ADDENDUM NO. 01

PROJECT NAME: **Espada Road - IH 410 to Ashley Rd.**

TCI PROJECT NO: **40-00246/40-00419**

Plan Sheets, Sheet 4, 13, 14, 18, 82, 83, 87, 104, SAWS Water Sheets (attached to this Addendum) is revised as follows:

ESPADA RD
ILLUMINATION AND INTERCONNECT QUANTITIES

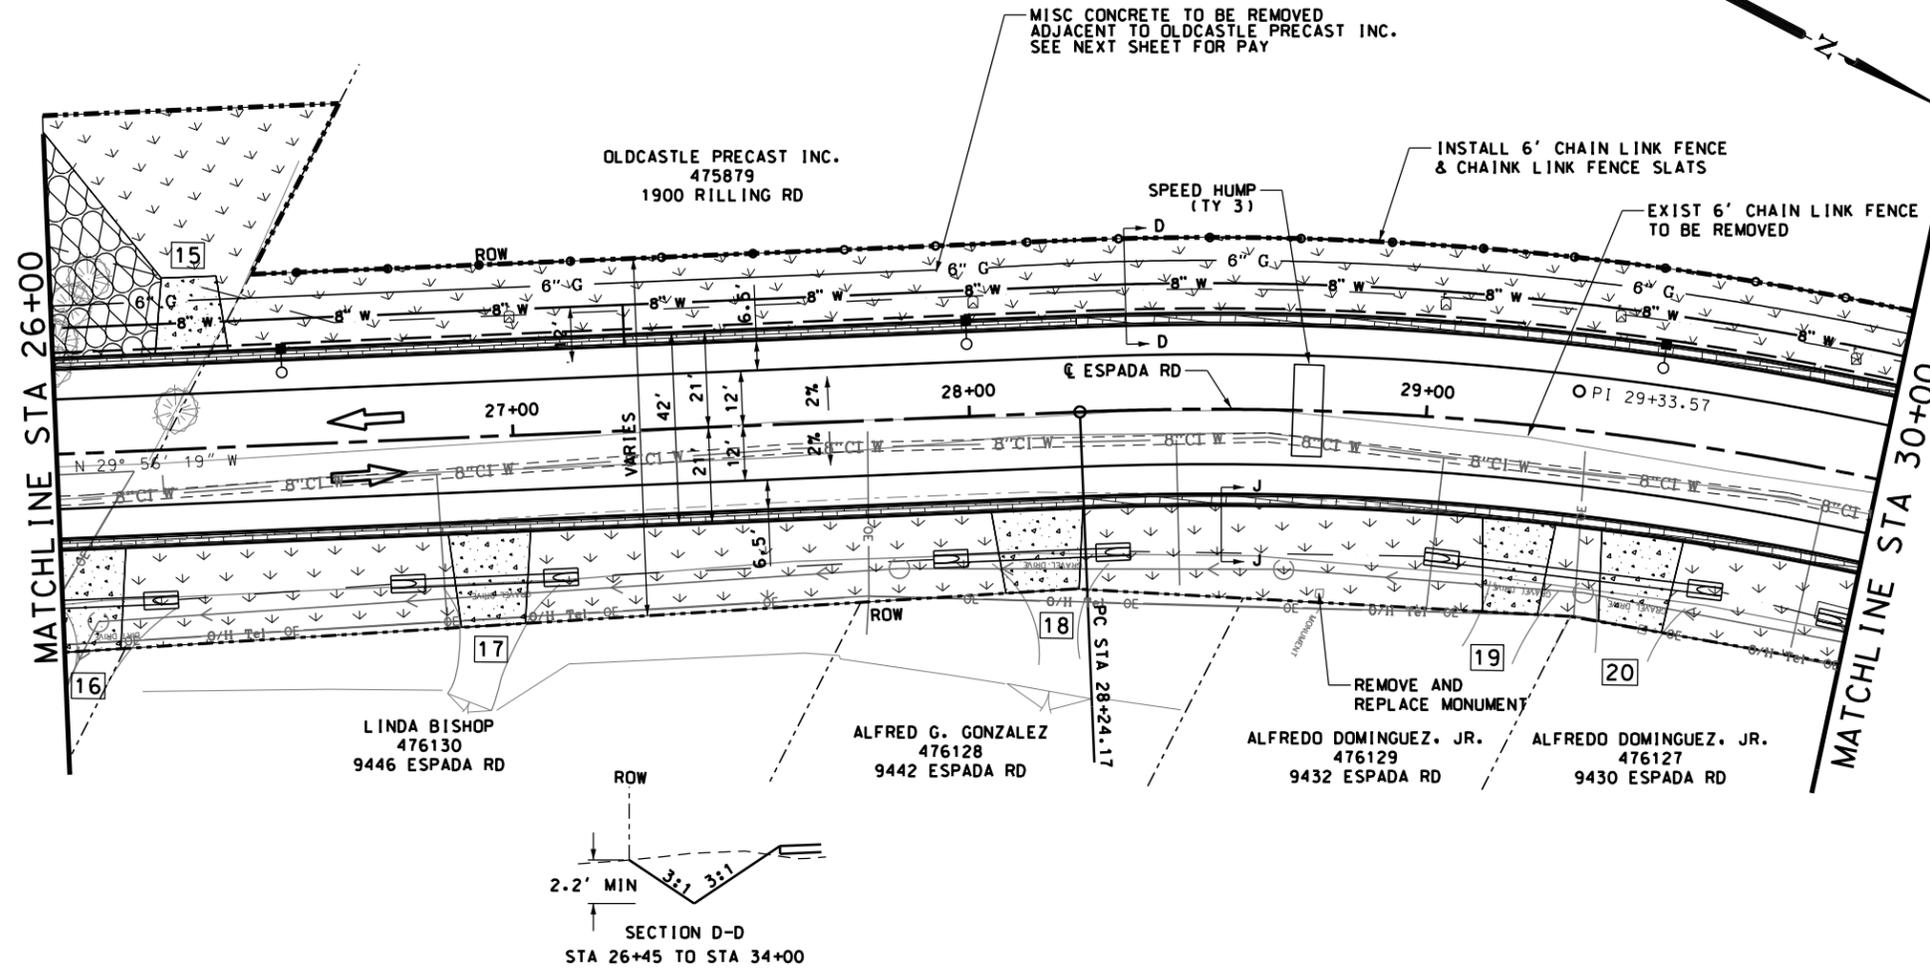
- ELECTRICAL SERVICES (PER INSTALLATION): 1 EA
 - REMOVE ELECTRICAL SERVICES (PER REMOVAL): 1 EA
9. Sheet 18: Added quantities on Illumination Summary relating to ITSD conduit. Plans are currently under production.

ESPADA RD
PLAN & PROFILE SHEET
STA 26+00 TO STA 30+00

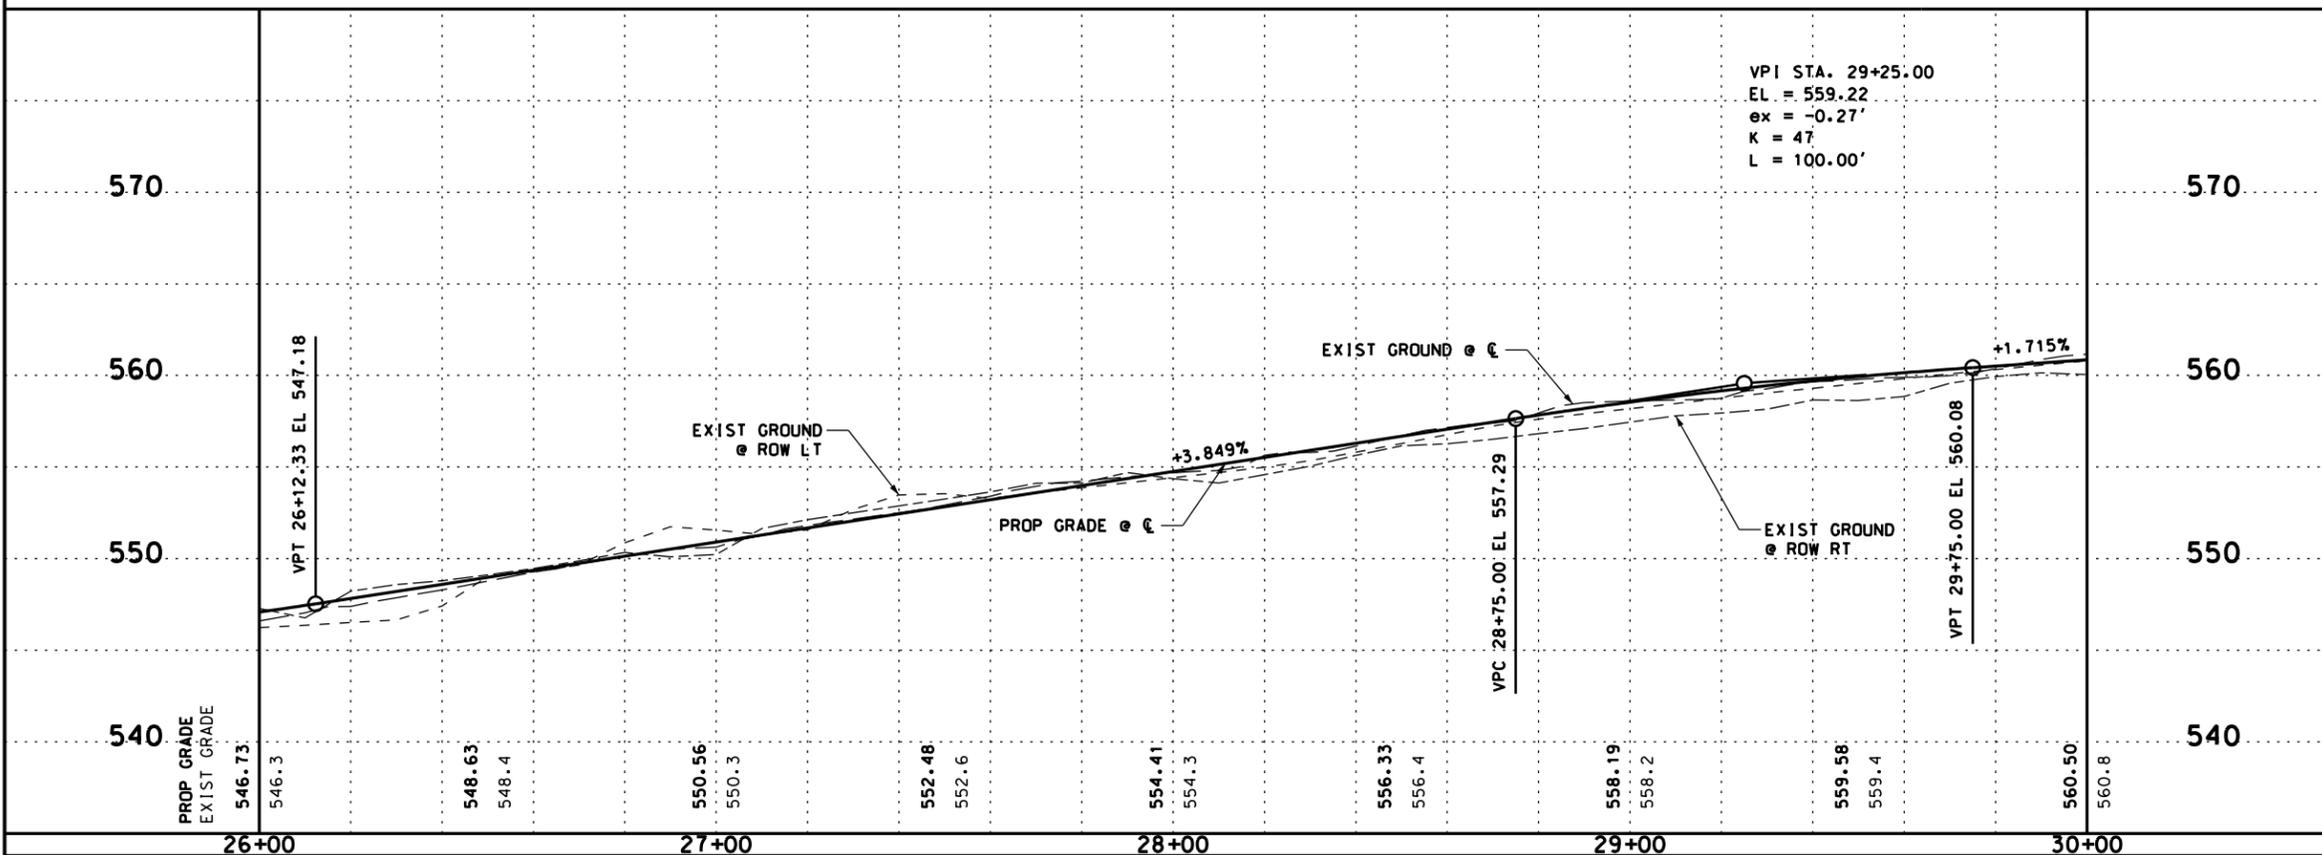
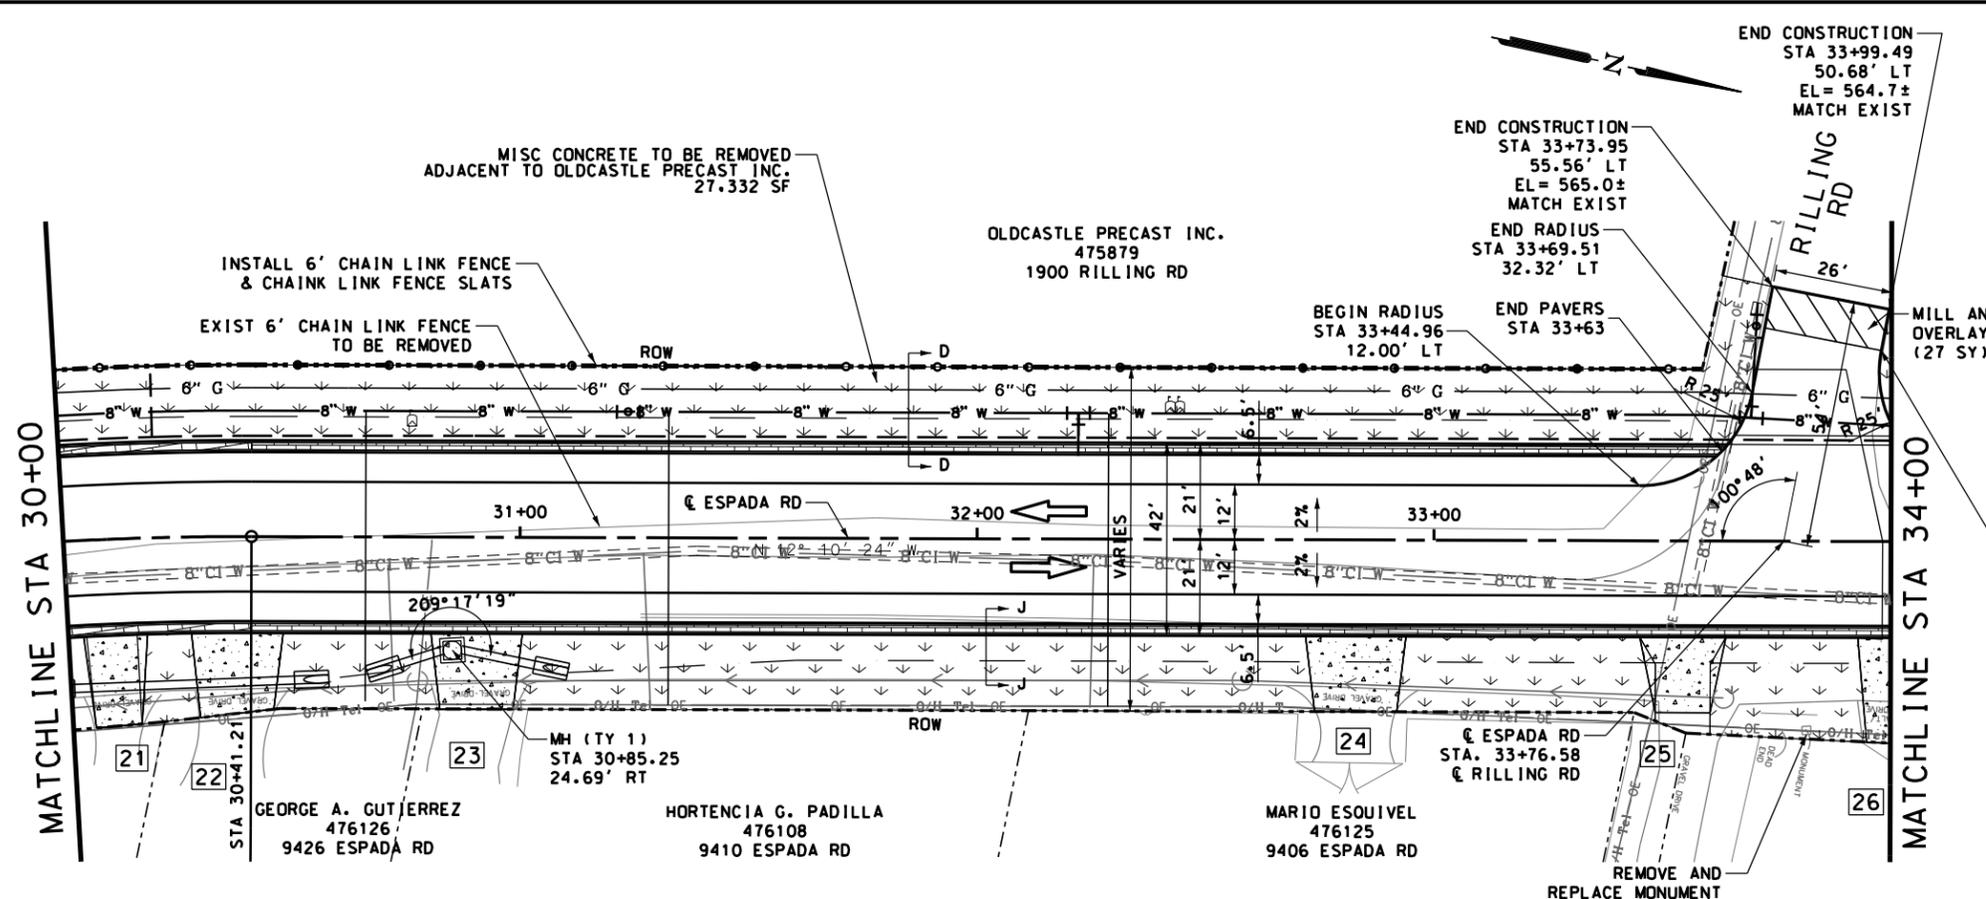
6. Sheet 13: Added quantity for Portable Changeable Message Sign: 100 Days
7. Sheets 14, 82, & 83: Added quantities revision relating to Hauling of Misc Concrete adjacent to Oldcastle Precast Inc as well as removal of wording relating to hauling of concrete shall be considered subsidiary to Prep ROW:

- Remove Miscellaneous Concrete: 27,332 SF
8. Sheets 14 & 87: Added quantities relating to Electrical Service removal and relocation, due to potential conflicts at 9143 Espada Road:

NO.	DESCRIPTION	DATE
ADD 1	REVISED CONC REMOVAL NOTE	2/17/16
